Re: DART+ South West Electrified Heavy Railway Order - Hazelhatch & Celbridge Station to Heuston Station, and Hesuton Station to Glasnevin
County Dublin and County Kildare

**Property: Kilmainham Square (The Old
Chocolate Factory) Apartments**

**Submission to the Draft Railway Order
[DART+ South West Electrified Heavy
Railway Order 2023]**

Figure 10. Railway Works Plan for the section of the railway adjacent to the subject property (Site Layout Plan No. 13)

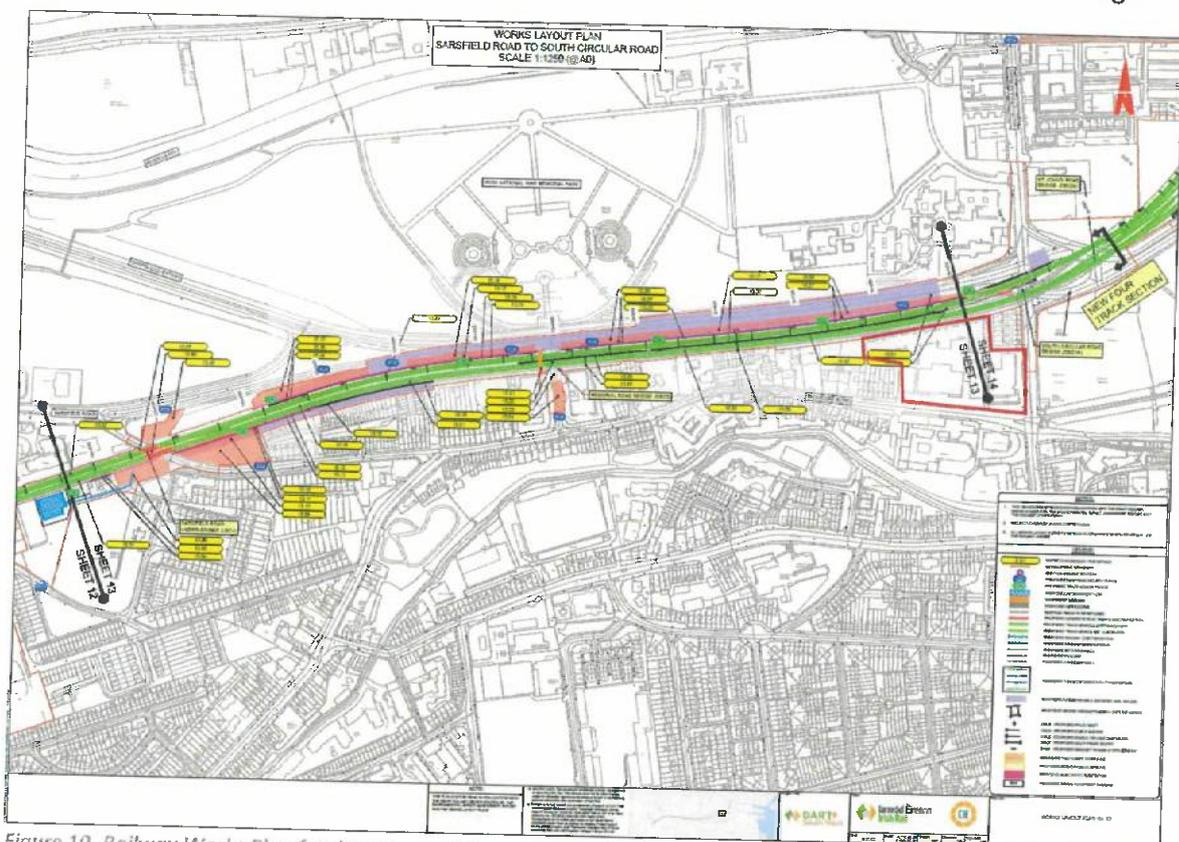
As marked up on the drawing, work plan at this section of the road involves proposed track works for electrified and not electrified extension of the railway (green continuous and dashed line respectively), as well as proposed retaining wall to the northern boundary of the railway casement.

There is also "reconstruction of existing roads over the area of the new 'cut and cover' buried portal structure located at South Circular road Bridge (OBC1A). This will include median and junction approach islands. Works will include the reinstatement of the road drainage system and resurfacing of the junction with associated lane marking. The works will entail extensive temporary traffic management measures, including lane diversions and temporary lane closures and temporary and permanent utility diversions" (work detail no. 13.31 on the drawing).

Figure 15. Structures Plan for the section of the railway adjacent to the subject property (drawing DP-04-23-DWG-RO-TTA-18898)

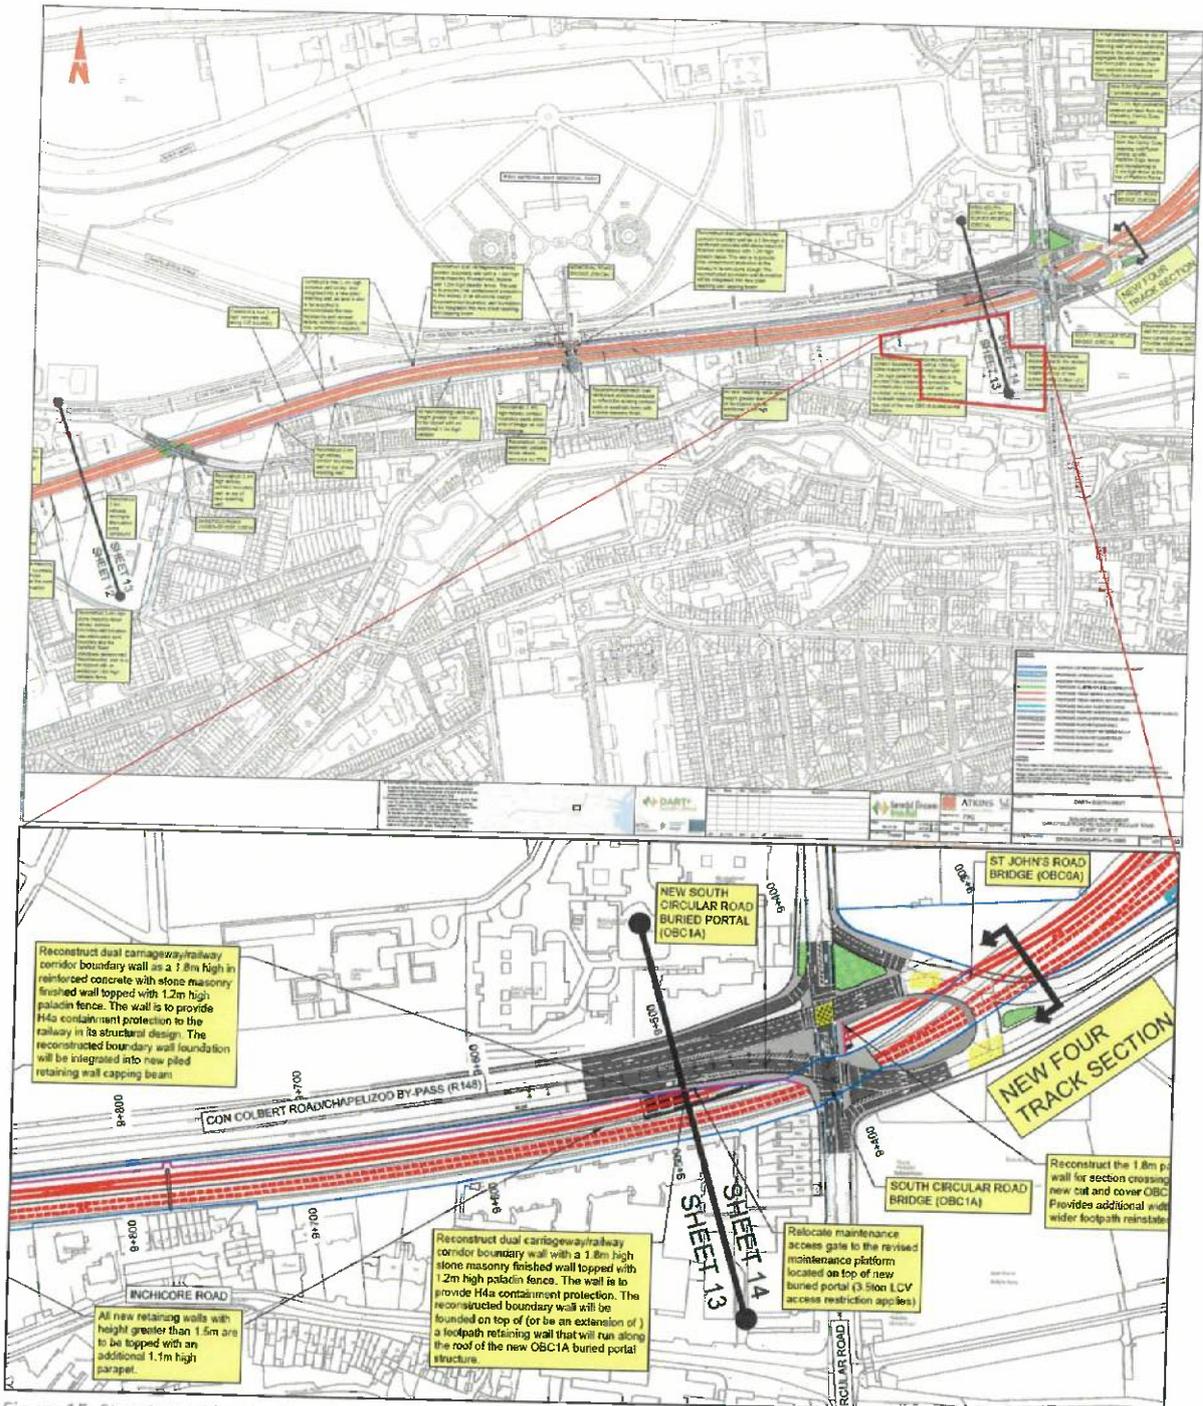
As shown on the above drawing Structures Plan – Boundary Treatment (Sheet 13 of 17), Book 3 of the Order drawings, to facilitate the extension and upgrade of DART+ South West in relation to the subject site at Kilmainham Square Apartments, it involves re-construction of: (1) dual carriageway/railway corridor boundary wall with a 1.8m high stone masonry finished wall topped with 1.2m high paladin fence. The wall is to provide H4a containment protection. The reconstructed boundary wall will be

founded on top of (or be an extension of) a footpath retaining wall that will run along the roof of the new OBC1A buried portal structure; (2) dual carriageway/railway corridor boundary wall as a 1.8m high in reinforced concrete with stone masonry finished wall topped with 1.2m high paladin fence. The wall is to provide H4a containment protection to the railway in its structural design. The reconstructed boundary wall foundation will be integrated into new piled retaining wall capping beam; and (3) relocation of the maintenance access gate to the revised maintenance platform located on top of new buried portal.

Figure 21. The orange line outlines the area of proposed measures to be incorporated for biodiversity protection.

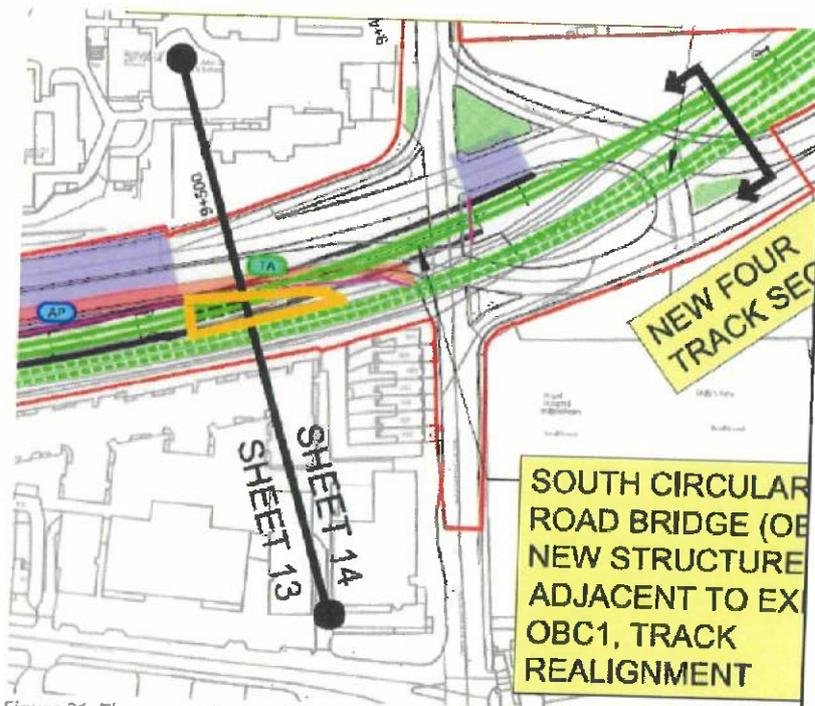
The orange outlined as shown on the snippet above, appears as an error which needs to be aligned with the magenta line. Also, referring to Chapter 4 of the EIAR where the proposed Project has been described in detail, the proposed works for this section of the railway includes widening of the rail corridor for 4 tracking/new portal structures, as well as new retaining walls. Therefore, it is not clear where the cut and cover tunnel is taking place at this section of the railway. Noted as shown on Figure 6 of this submission, there is a line of mature trees to the north boundary of the railway casement where the extension of the railway is proposed.
